DART SERVICE INSTRUCTION

TO AMEND INSTALLATION INSTRUCTIONS IIN-D117-1044 REV. B OR LATER APPROVED REVISION AND
INSTRUCTIONS FOR CONTINUED AIRWORTHINESS ICA-D117-1044 REV. 0 OR LATER APPROVED REVISION

REF. FAA STC: SR02578SE

**Figure 1 - D5549-011 MODIFIED WITH D5549-5
Fwd Beam Assembly, LH**

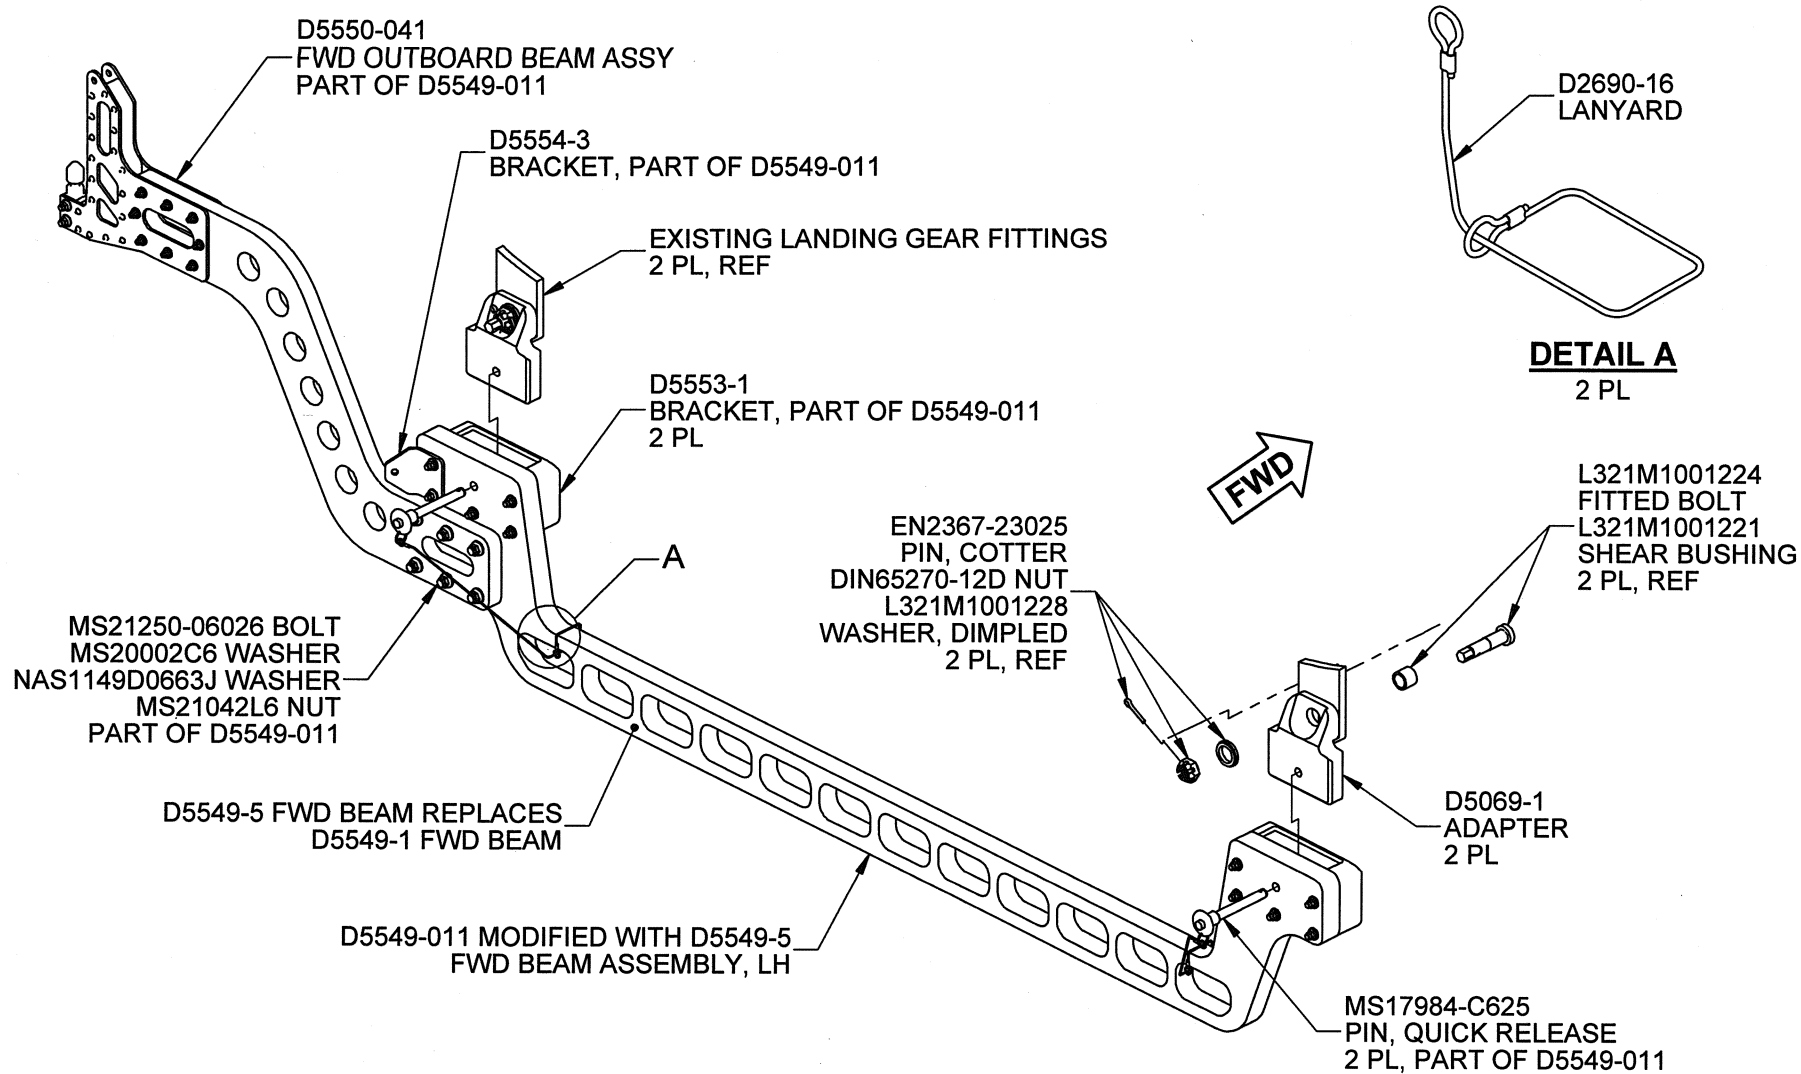
It has come to Dart's attention that BK117 C-2/D-2 aircraft equipped with the P/N 232-713-00 Cargo Hook may encounter interference between the fwd cable assembly and the D5549-1 Fwd Beam that is part of D5549-011/-012 Fwd Beam Assemblies (LH/RH) that are installed as part of the D117-1044-113/-114 Quick Release Basket Mounting Provision Kits at CHG 001. The purpose of this DSI is to introduce an alternate D5549-5 Fwd Beam to prevent the fwd beam from interfering with the fwd cable assembly that is used on the P/N 232-713-00 Cargo Hook.

- 2.5 Re-install the following parts onto the new D5549-5 Fwd Beam: 2x D5553-1 Brackets, D5554-3 Bracket and D5550-041 Fwd Outboard Beam Assy in the same configuration as they were installed on the D5549-1 Fwd Beam as shown in Figure 1 (LH) or Figure 2 (RH) of this DSI. Torque fasteners per Table 5-2 of ICA-D117-1044.

- 2.6 Install 2x D2690-16 Lanyards the same way as the existing D2690-13 Lanyards were installed on the D5549-011/-012 Fwd Beam LH/RH, looping around the end pockets of the new D5549-5 Fwd Beam. Connect a MS17984-C625 Quick Release Pin to each D2690-16 Lanyard, as shown in Figure 1 (LH) or Figure 2 (RH) of this DSI.
